DART SERVICE INSTRUCTION

TO AMEND INSTALLATION INSTRUCTIONS IIN-D412-694 REV B
AND INSTRUCTIONS FOR CONTINUED AIRWORTHINESS ICA-D412-694 REV 1

DRAWING NO. **DSI 9715** REV. A
SHEET 1 OF 2

TITLE **REPLACEMENT WINDOW KIT** SCALE NTS

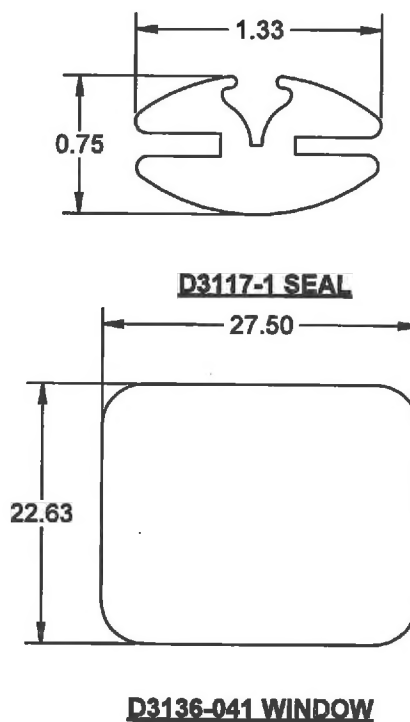
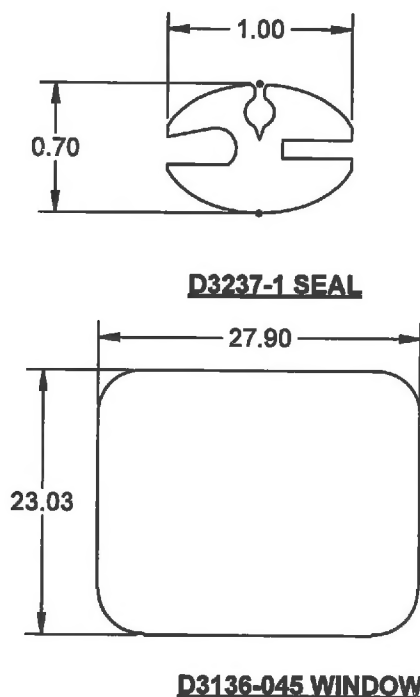
Installation procedure for the D412-694-115 Replacement Window Kit is identical to the installation of the D412-694-015 Window Kit (Section 3.4) of IIN-D412-694. The following diagram shows the differences between the D3117-1 Seal and the D3237-1 Seal and the differences between the D3136-041 and D3136-045 windows.

NOTE: D3136-041 Windows are **NOT** compatible with D3237-1 Seals and D3136-045 Windows are **NOT** compatible with D3117-1 Seals
